**TECHNICAL BULLETIN**  
**Bell Helicopter** **TEXTRON**  
A Subsidiary of Textron Inc.

**NO** 407-01-29

**SUBJECT:** **GROOVED FREEWHEELING CONE SET 407-040-548-101, INTRODUCTION OF.**

**HELICOPTERS AFFECTED:** 407, Serial numbers 53000 through 53447.

**Figure 1. Grooved Cone Set - Installation**

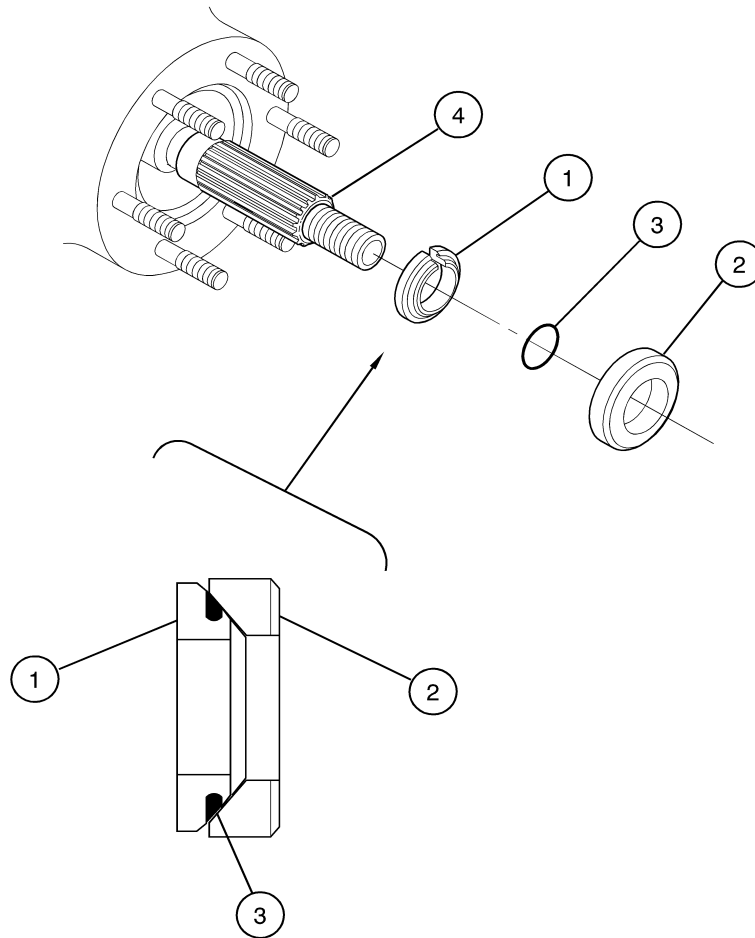
It has been reported to Bell Helicopter that cone set 406-040-548-101 can fall off the freewheel output shaft during installation. This bulletin introduces cone set P/N 406-040-548-101 to correct this problem. This new cone set is manufactured with a groove on the outer diameter of the cone that allows the installation of packing P/N M83248/1-018. Use of this new packing makes sure that the cone set remains in position during the installation of the spacer and the freewheel aft support assembly.

Cone set 407-040-548-101 and packing M83248/1-018 are the direct replacement for cone set 406-040-548-101.

1. Install the cone set (1, figure 1) as follows:
  - a. Install cone set (1) in the groove of the aft end of the freewheeling shaft (4).
  - b. Lubricate the packing (3) with assembly fluid (C-024, BHT-ALL-SPM).
  - c. Install the packing (3) in the groove of the cone set (1).
  - d. Install the spacer (2).
2. Complete the installation of the freewheel assembly (BHT-407-MM, Chapter 63).
3. Re-identify the freewheel assembly as follows:
  - a. If the forward seal, 407-340-102-101, is not installed as per TB 407-00-27, re-identify the freewheel assembly as follows:
